Subject: FW: Urban Design testing of HOB and FSR - RR-2023-12 - 407-511 King Georges Road, Beverly Hills

The Urban Design Advisory team has reviewed the Beverly Hills Town Centre Planning Proposal (May 2024) and the Urban Design Study (April 2024). We understand that the planning proposal aims to provide approximately 560 new dwellings (44,800m² residential GFA) along with around 12,219m² of retail, dining, and evening entertainment floor space (Planning Proposal p.11).

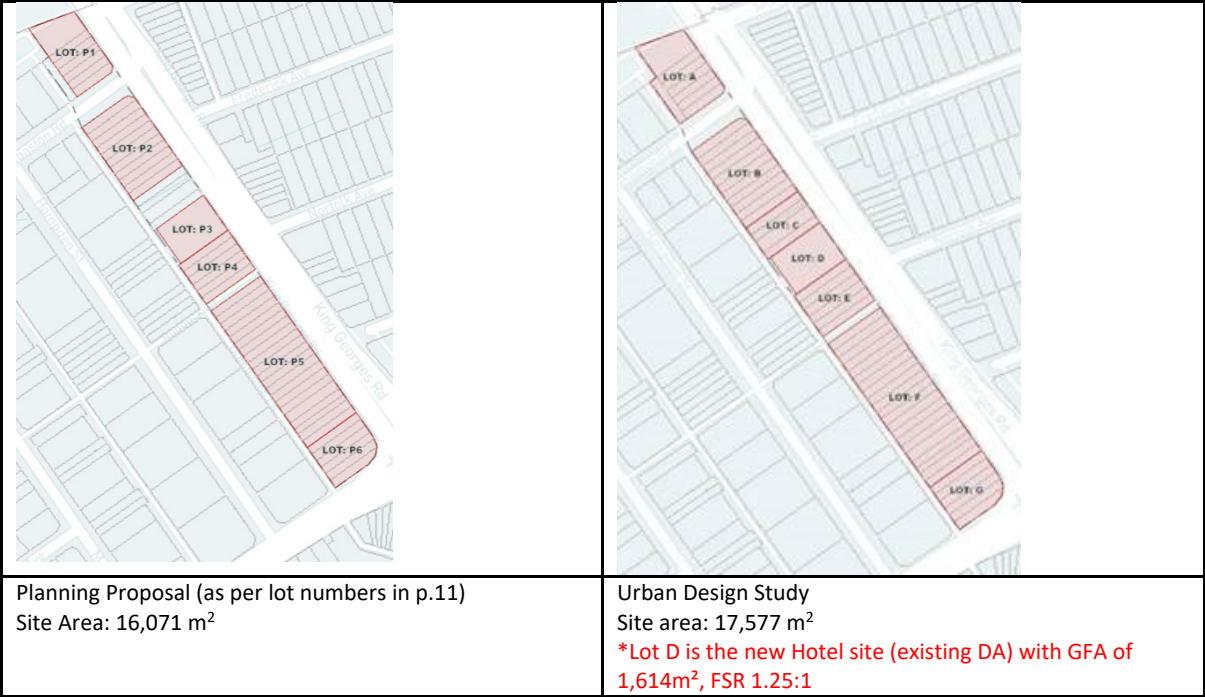
There is a discrepancy between the site boundary outlined in the planning proposal and the Urban Design Study (see figures below). The Urban Design Study includes all 57 lots within the site boundary in the proposed scheme. However, on page 11 of the planning proposal, five lots are excluded, including Lot 2 DP208878 (Council-owned lot) and four lots related to the proposed hotel site (443-445 King Georges Road).

It is recommended to clarify the site boundary for the proposed controls—whether it is 17,577m² as stated in the Urban Design Study or 16,071m² as per the planning proposal—as this will affect the calculation of the Floor Space Ratio.

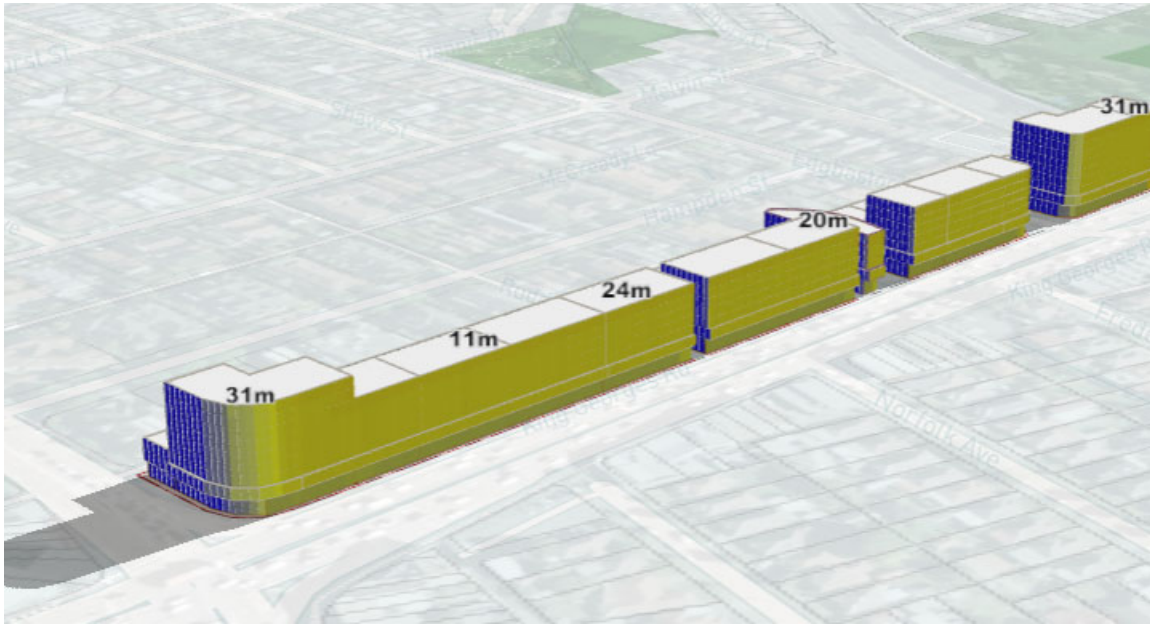
The proposed blanket FSR of 3.5:1 across the site does not align with the maximum Heights of Buildings set at 11m, 24m, and 31m for the local center. Our analysis indicates that the achievable gross FSR across the site would be 2.7:1, and the net FSR (excluding roads and site-through links) would be 2.9:1. Additionally, the individual developments in Lot A and Lot G reach an FSR of over 3.5:1 when the height increases to 9 storeys, while other lots achieve less than 2.8:1 (refer to the figure below).

To align with the HOB, it is recommended that the blanket FSR be reduced to 2.7:1 or specific FSRs be proposed for each site. If the FSR of 3.5:1 is not reduced, there is a risk of proponents seeking to increase height through Clause 4.6 for individual developments.

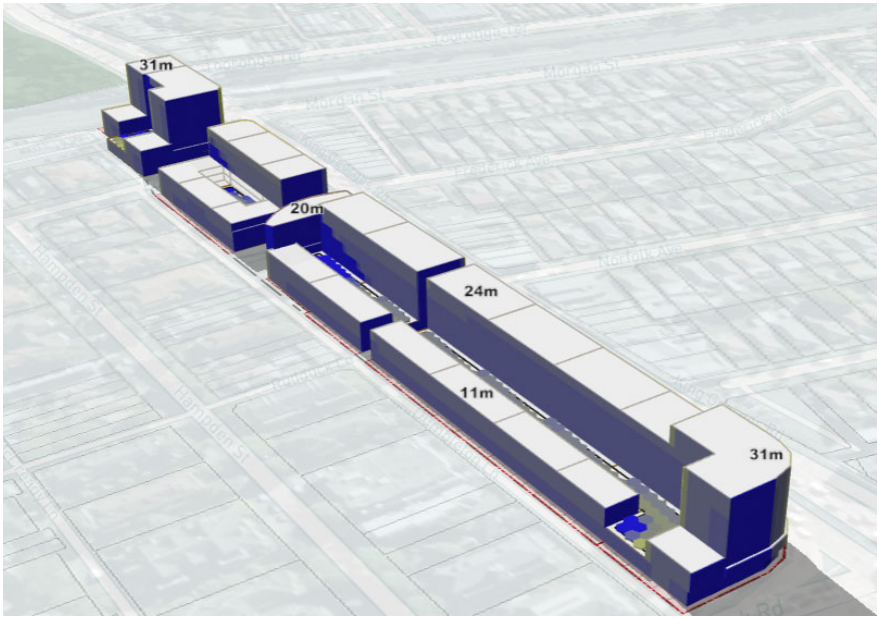
The distribution of retail is at the ground floor across King Georges Road and some corner lots at Dumbleton Lane (figure below). Despite this, there is still a shortage of GFA. It is noted that even if all ground floors were dedicated to retail uses, including across the lane (while it is not feasible for retail use at the lane), the proposal would still only achieve 8,855m² of GFA. Another option is to provide the remaining non-residential GFA on the first floor across King Georges Road, if feasible.
